# Peer review - Transport

## Coniston Park Plan Change – Farm Road and Racecourse Road, Ashburton

<b>Prepared for</b>	Ashburton District Council
<b>Job Number</b>	ADC-J007
<b>Issue Date</b>	26 June 2024
<b>Prepared by</b>	Mat Collins, Associate Transportation Engineer
<b>Reviewed by</b>	Dave Smith, Technical Director

Figure 1.2 Outline Development Plan

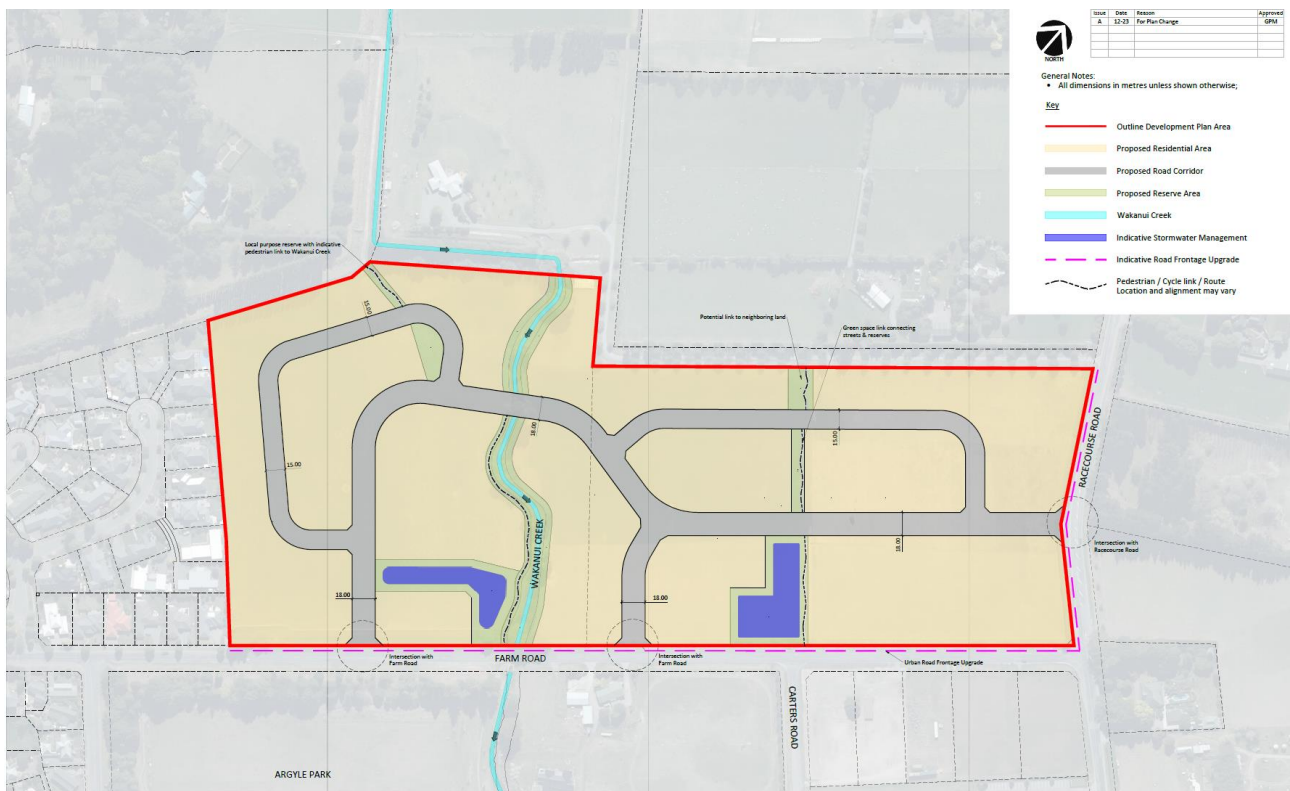
We note that the ITA identifies that the Outline Development Plan (ODP) does not provide the required intersection spacing on Racecourse Road, between the proposed primary road and existing Farm Road intersection. We recommend that the ITA provide commentary on matters given in Austroads Guide to Road Design Part 4: Intersections and Crossings: General (AGRD-04) – Appendix B, in particular consideration of Safe Intersection Sight Distance and Approach Sight Distance.

Further, we recommend that a concept design is provided for the Racecourse/ Primary Road intersection, including how this integrates with the existing right turn bay and taper on Racecourse Road, to confirm that this can comply with Austroads guidance for minimum right turn bay and taper length. This should include consideration of the existing speed limit on Racecourse Road, while it is possible that the speed limit on Racecourse Road will be reduced if the site urbanises, this can only be undertaken by the Road Controlling Authority and is therefore not an outcome that can be controlled by the Plan Change.

The ITA considers that the spacing for the two proposed intersections on Farm Road comply with District Plan requirements for a 50 km/hr speed limit. We recommend that the ITA also comment on the spacing between the proposed intersections and the Farm Road/Carters Road intersection, as it appears that this may not comply with District Plan requirements for a 50 km/hr speed limit.
